ADDENDUM #3

Re: INVITATION FOR BIDS: **16-026-NT Memorial Park Community Center**

Addendum 3

FIRE WALL PARAPET

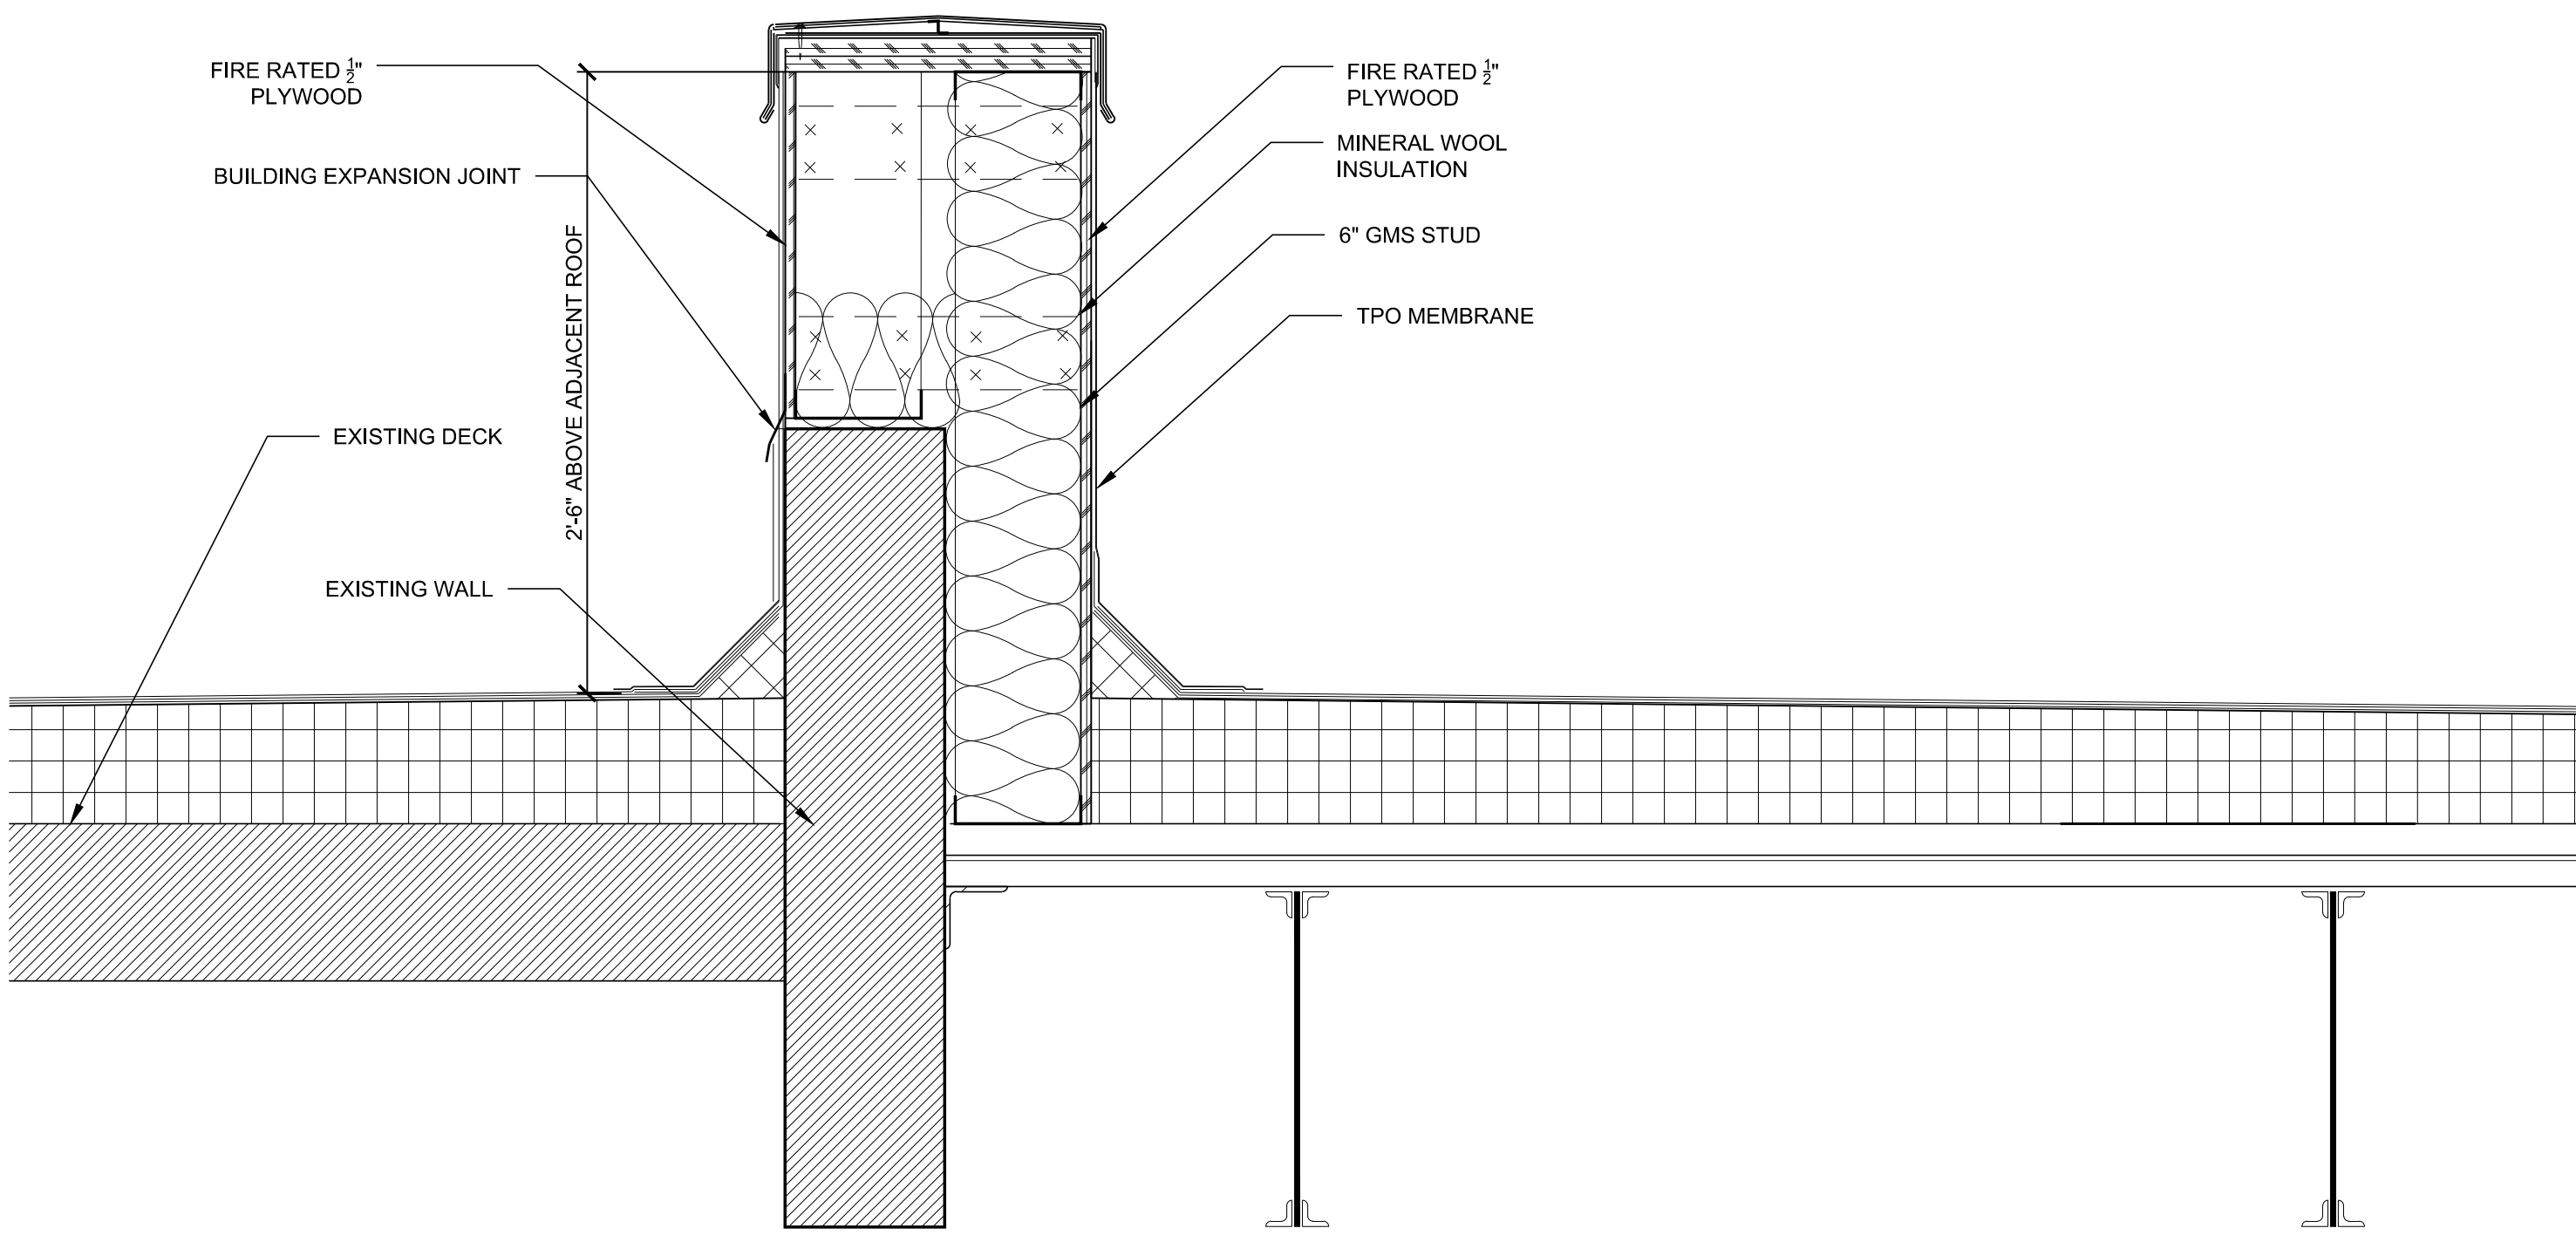
Item 2.7 Fire Wall Parapet Condition

The existing parapet wall height above the 2 hour rated wall assembly is to be extended to 30" above the adjacent decks. See attached drawing.
